ADDENDUM No. TWO

Project Name: Nature Center
White Clay Creek State Park

Contract No.: NAT25805-NATCTR
Date of Issue: Wednesday, May 20, 2026

1 LOWER FLOOR PLAN - POWER - NEW WORK
EP1.1 SCALE: 1/8" = 1'-0"

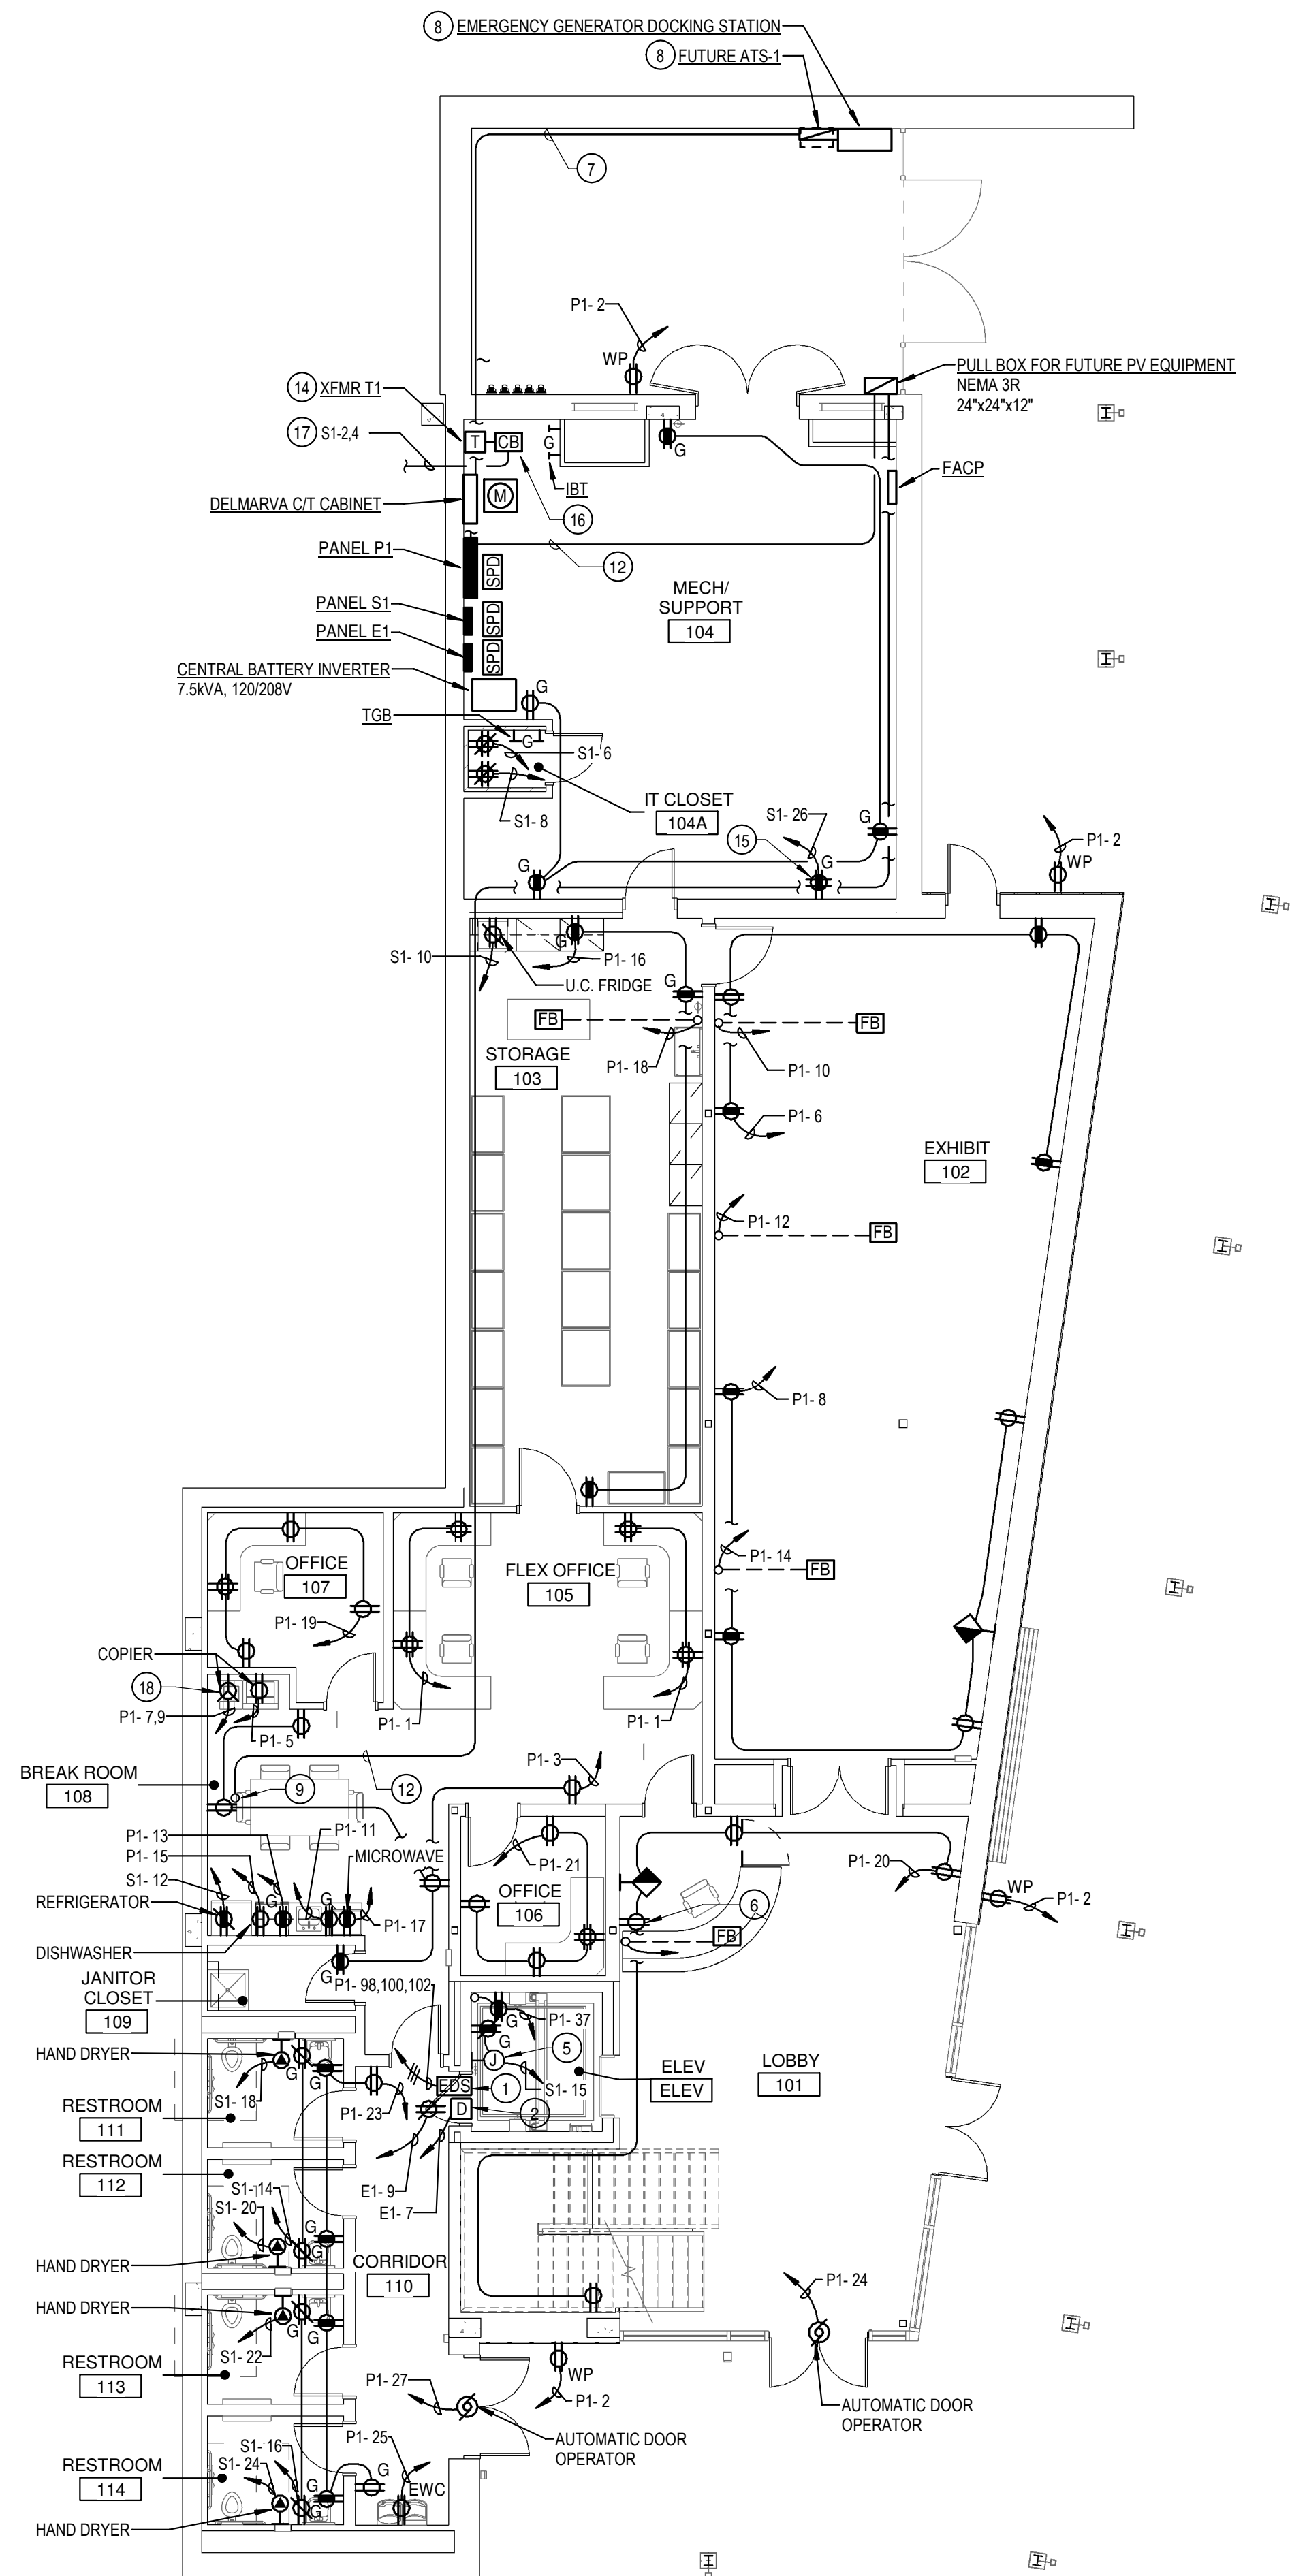
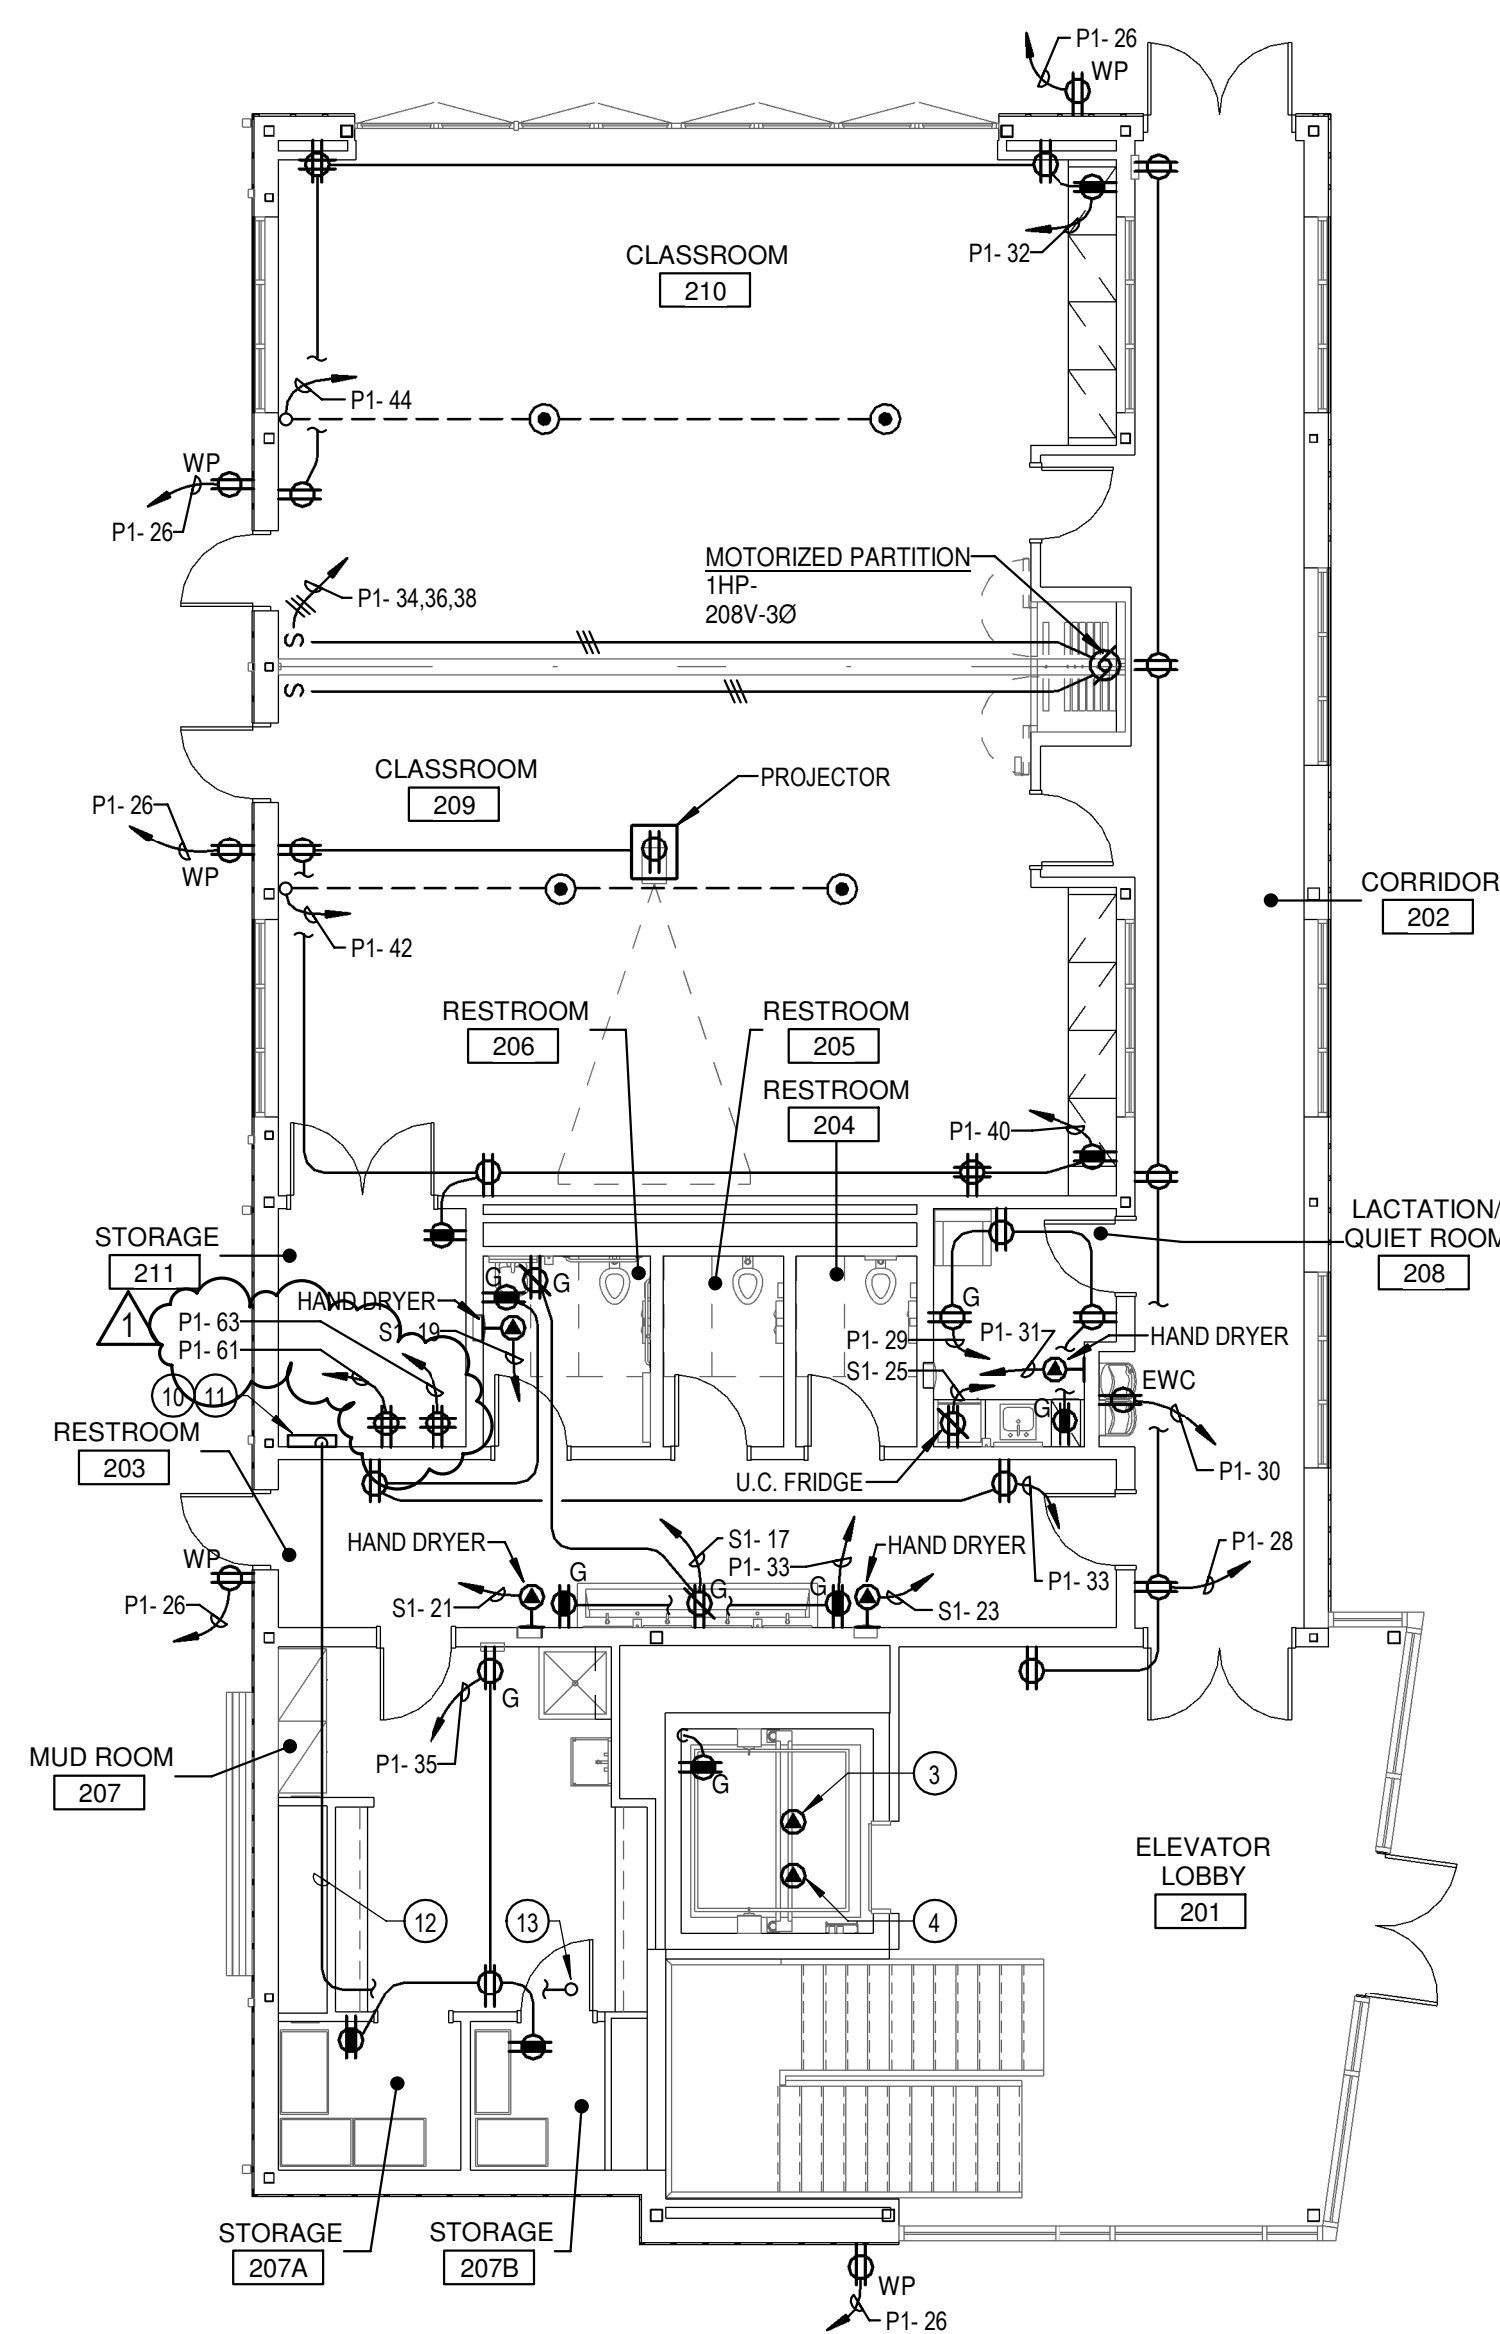
4. Sheet EP1.1: LOWER & UPPER FLOOR PLAN – POWER – NEW WORK
ADD: Two (2) quadruplex outlets were added to Storage 211 to serve new AV equipment associated with the overhead projector located in Classroom 209.
